**Expert Evidence Statement to the  
VPA Projects Standing Advisory Committee  
Referral 4 – Proposed Hume Planning  
Scheme Amendment for the  
Craigieburn West Precinct Structure Plan**

Prepared by Hamish Allan  
Manager Bushfire Planning & Design, Terramatrix Pty Ltd,  
for the Victorian Planning Authority (VPA)

April 2021

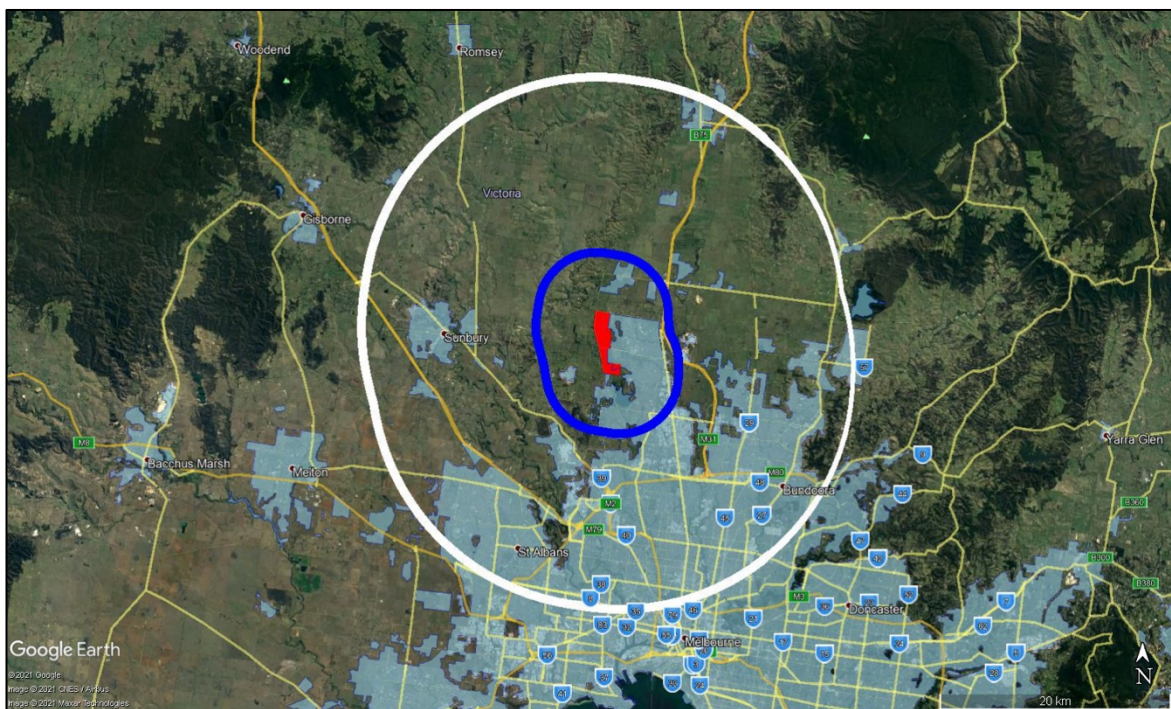
18. To reflect the most recent BPA extent gazetted 1<sup>st</sup> February 2021, I have updated Figure 1 on Page 8 of the report, in Figure 1 below, which shows BAL-LOW areas (i.e. land not designated as a Bushfire Prone Area (BPA)) in the broader surrounding landscape around the precinct.

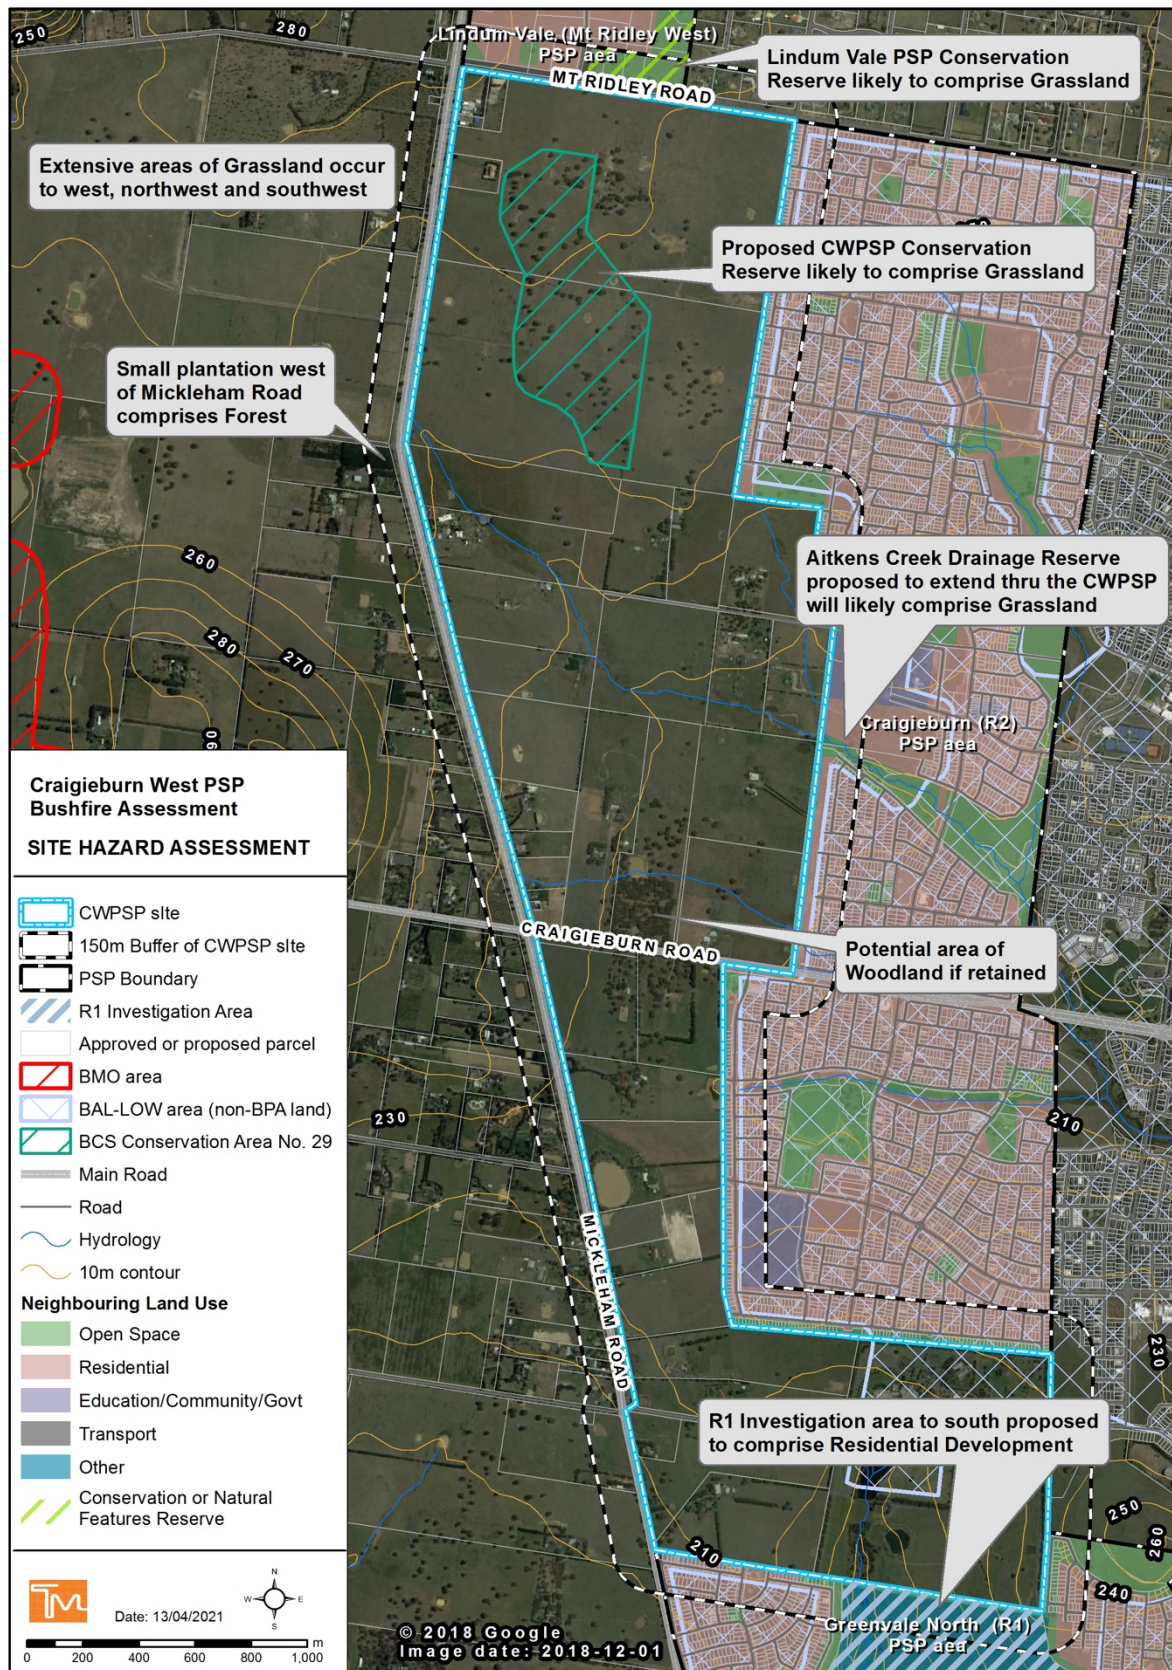
19. Similarly, *Map 2 - Bushfire Hazard Site Assessment Map* on page 22 of the report, *Map 4 - Bushfire Hazard Broad Landscape Assessment Map* on page 37 of the report and *Map 5 - Bushfire Hazard Local Landscape Assessment Map* on page 38 of the report, have also been updated in this evidence statement to show the most recent BPA coverage (see Maps 1, 2 and 3 following).
20. These maps have also been updated to show current parcel boundaries and roads.

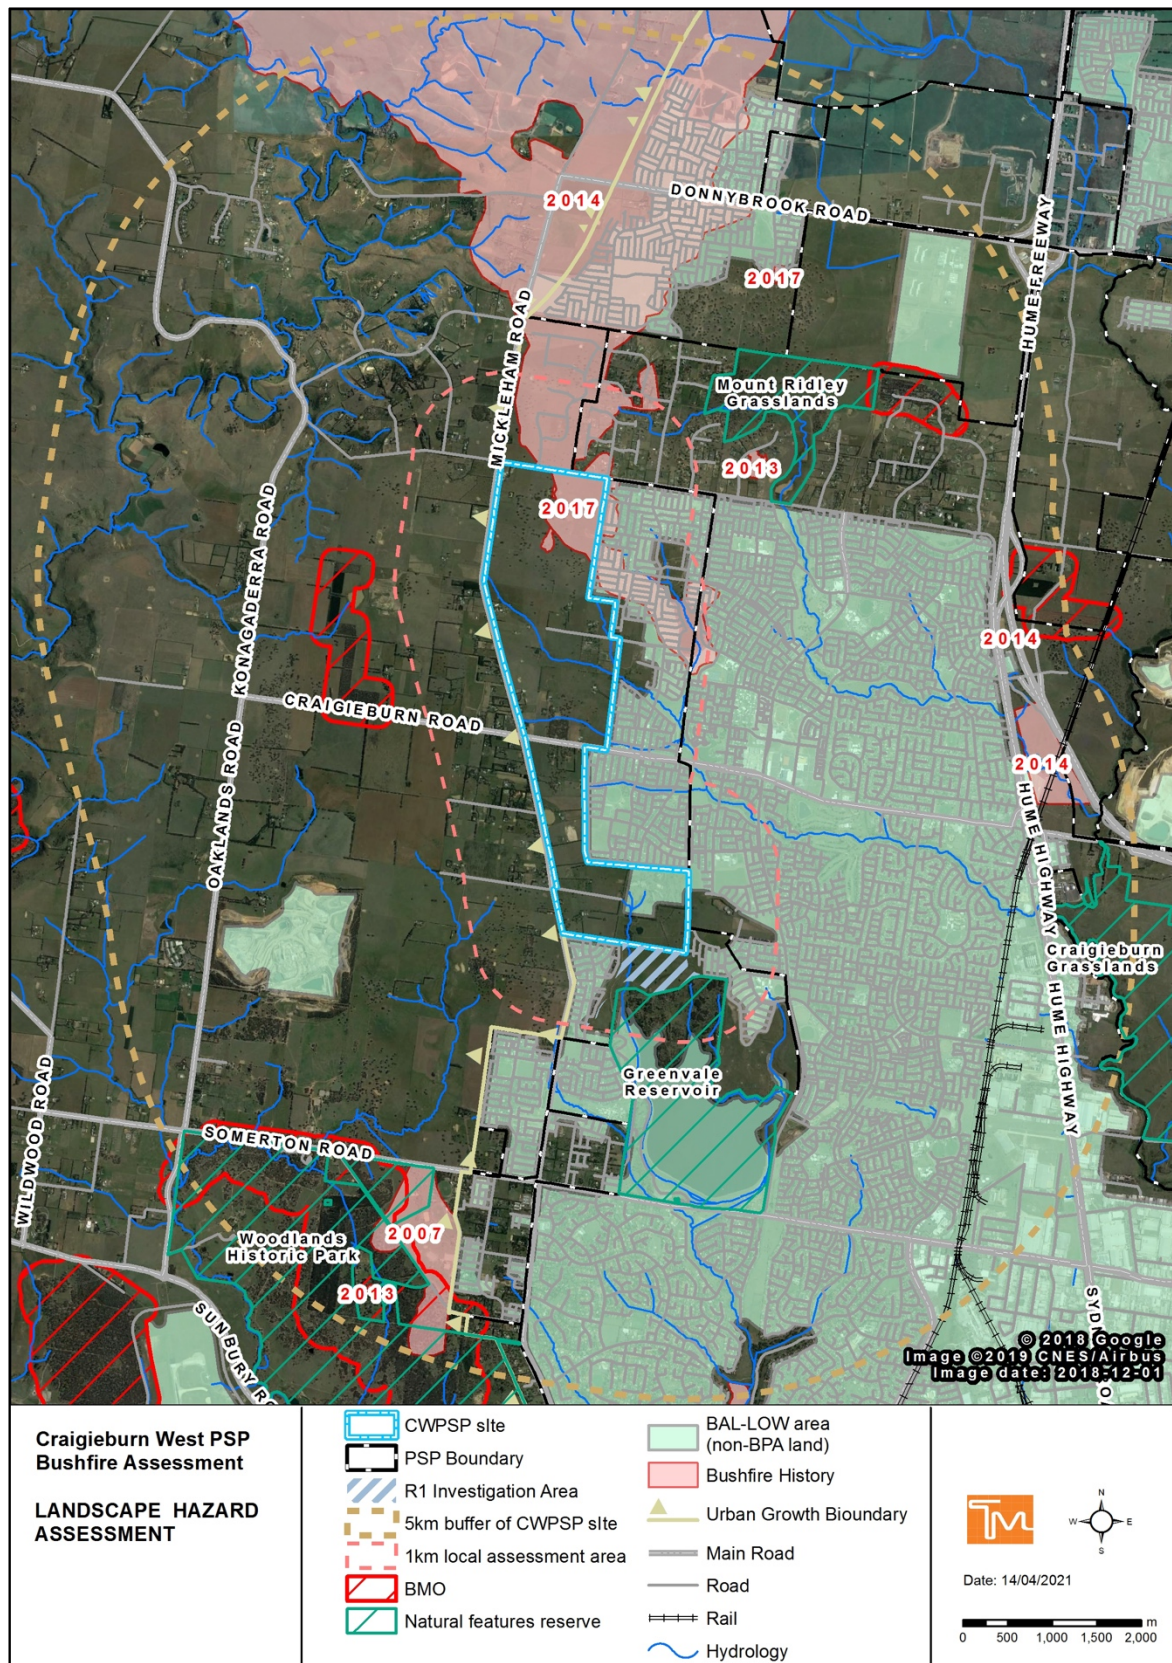
21. The draft Place Based Plan (PBP) shown in Figure 2 on page 10 of the report, has been superseded by the draft PBP provided as Plan 4 in the Craigieburn West PSP Draft for Public Consultation, dated November 2020 (VPA, 2020).

22. Accordingly, Maps 6 and 7 on pages 47 and 48 of the report, have also been updated with the more recent draft PBP, and are provided as Map 4 and Map 5 in this evidence statement. These maps have also been updated with current parcel boundaries and roads.

26. I consider that no matters of great significance arise from the changes made to the Draft PBP (VPA, 2020) in comparison to the Draft PBP in my report.
27. The only potential issue arises from the increase in the area of land (number and size of reserves) proposed to be set aside for a Waterway and/or Drainage function. As noted in the report, if these reserves are large enough and not managed in a low threat state, they may comprise a hazard for any adjacent houses, and if they pose a Grassland hazard, 19m setbacks for BAL-12.5 development may be needed.
28. I note that the 'Bushfire Plan' provided as Plan 7 in the Draft PSP, identifies the central large 'conservation' reserve in the north of the precinct and two of the drainage reserves will comprise 'Bushfire Hazard Area 2' (VPA, 2020).
